ADDENDUM NO. 01
January 13, 2022

To Drawings and Specifications dated December 17, 2021

CLINE ELEMENTARY SCHOOL CAMPUS REPLACEMENT
FOR FRIENDSWOOD I.S.D.

Prepared by: PBK
11 Greenway Plaza, 22nd Floor
Houston, TX 77046-1104
PBK Project No: 20380

P-102B

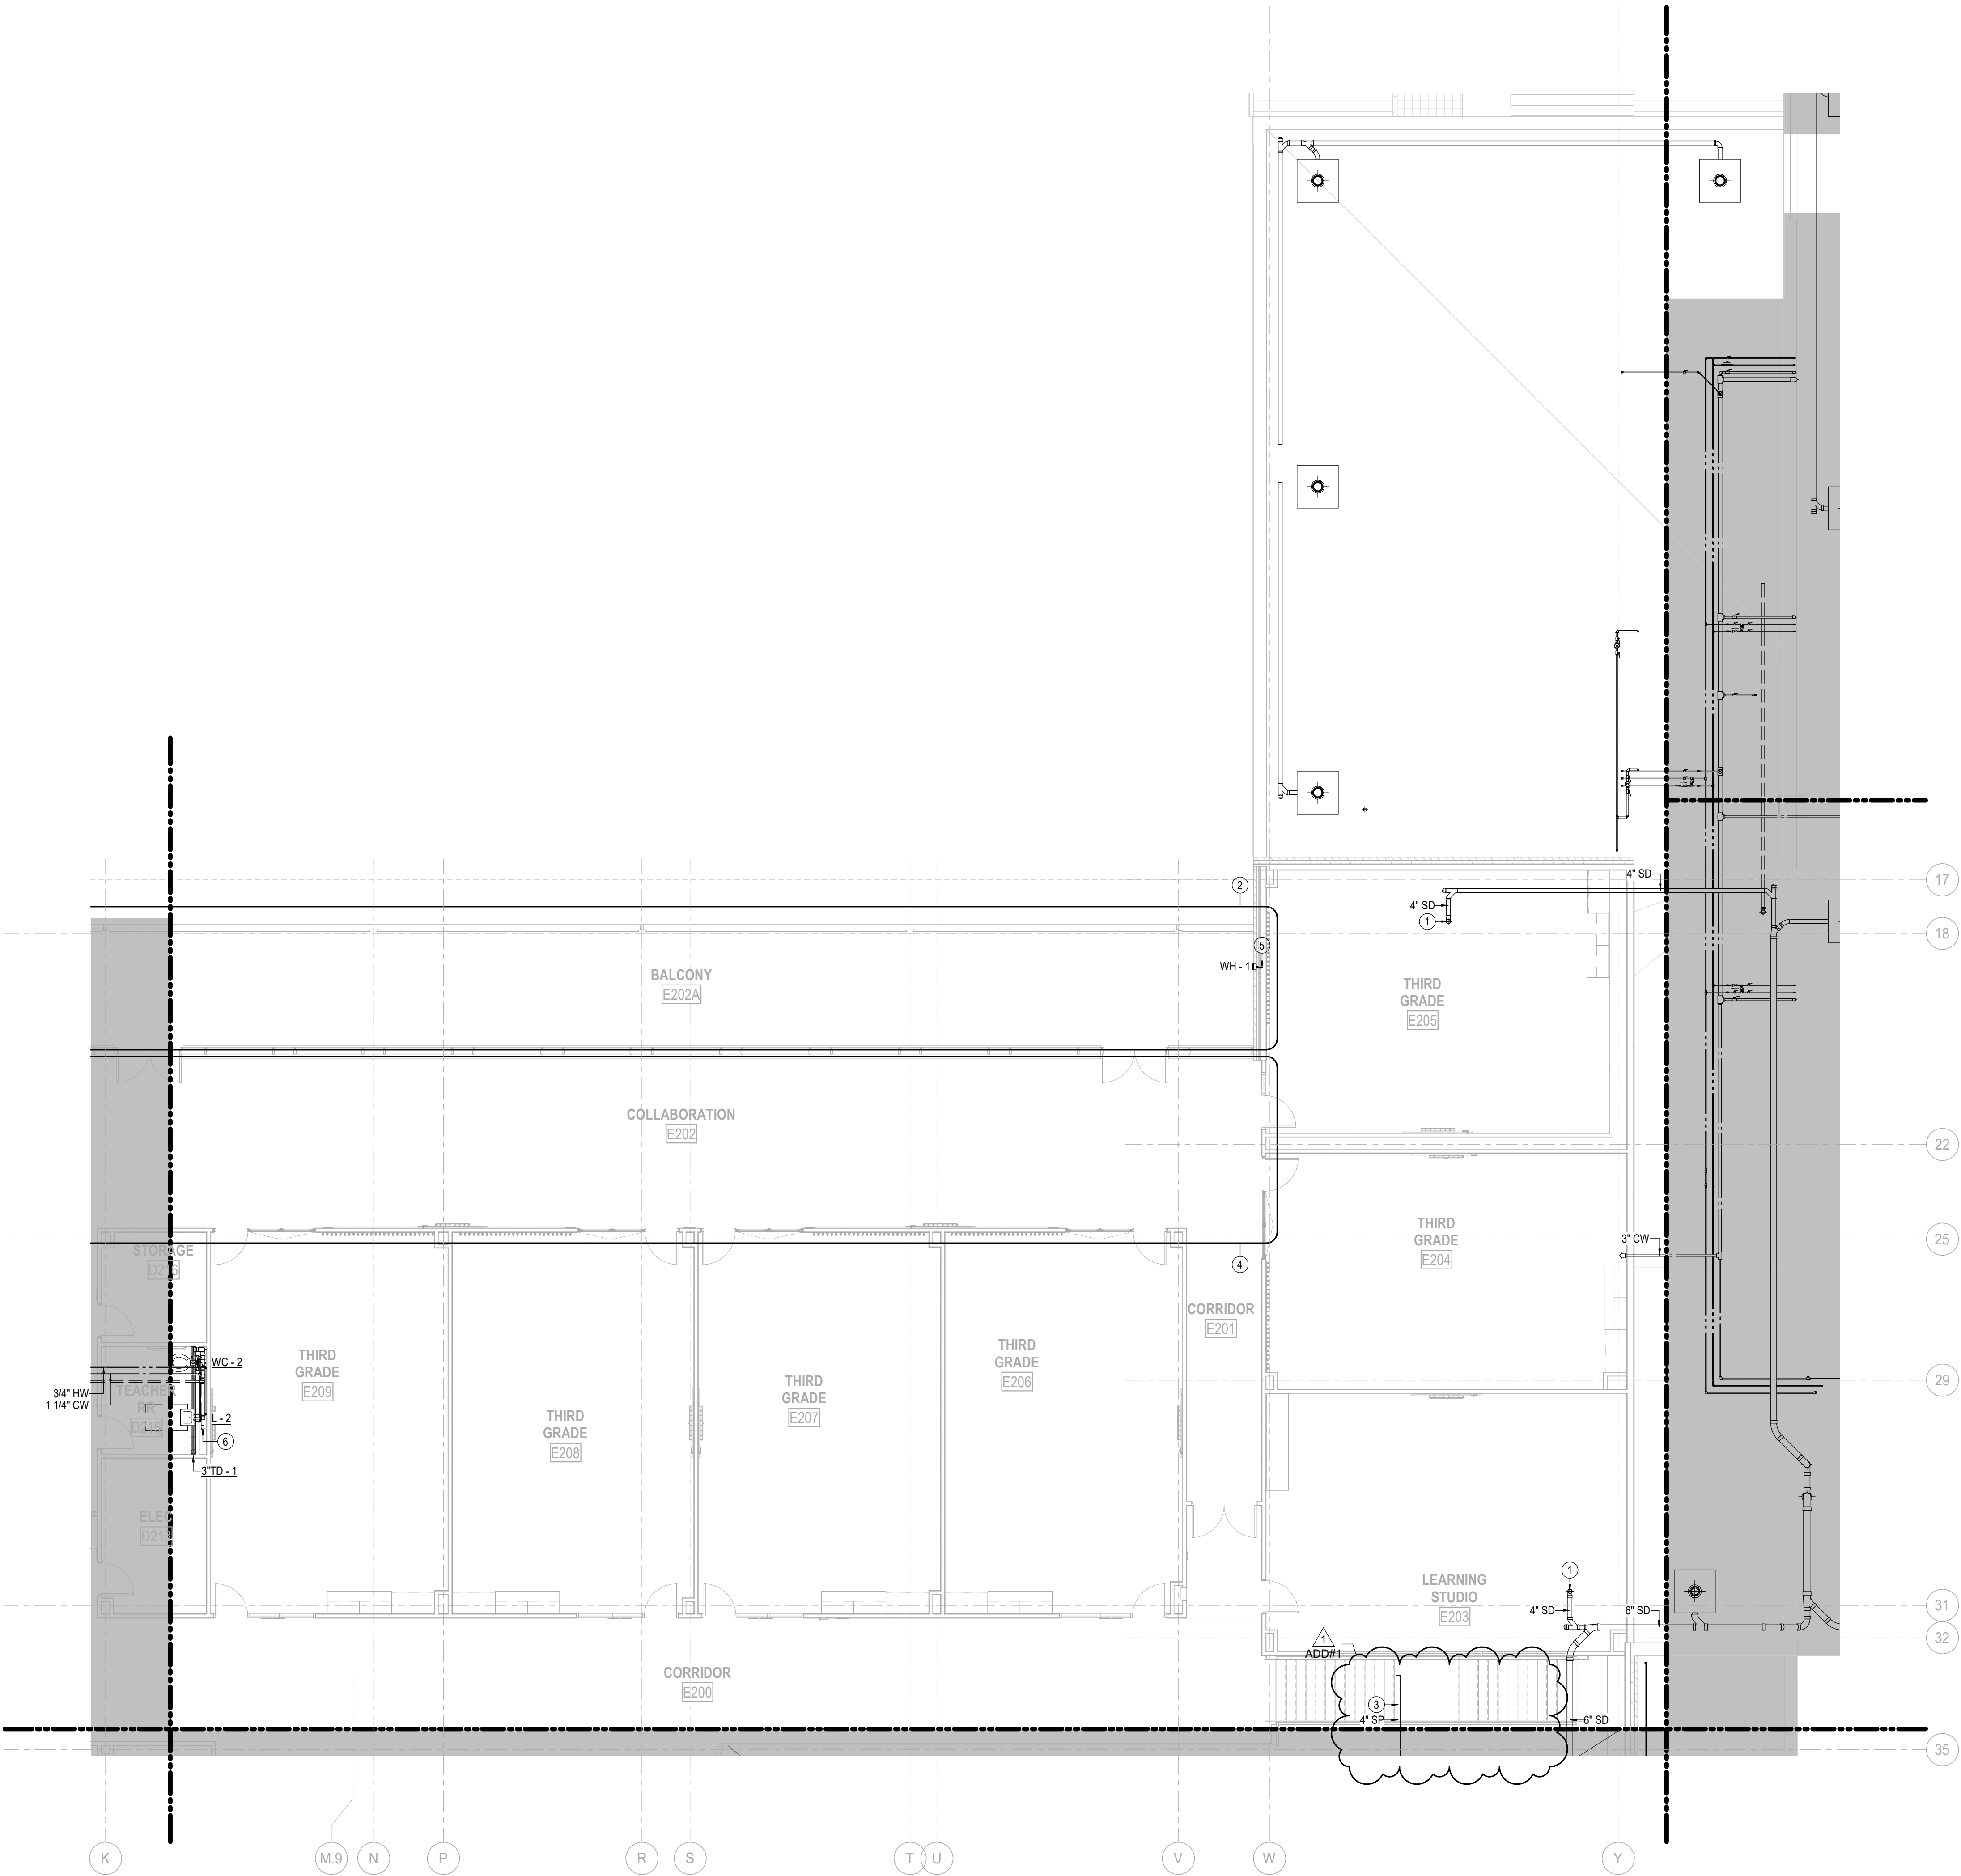
- Item No. 82 **Sheet P-102B – PLUMBING – 2ND LEVEL – FLOOR PLAN – AREA B**
- Modify sprinkler pipe routing above LEARNING COMMONS B103. Modify sprinkler main penetration through plan north structural beam to be through center of beam, per structure drawing details.
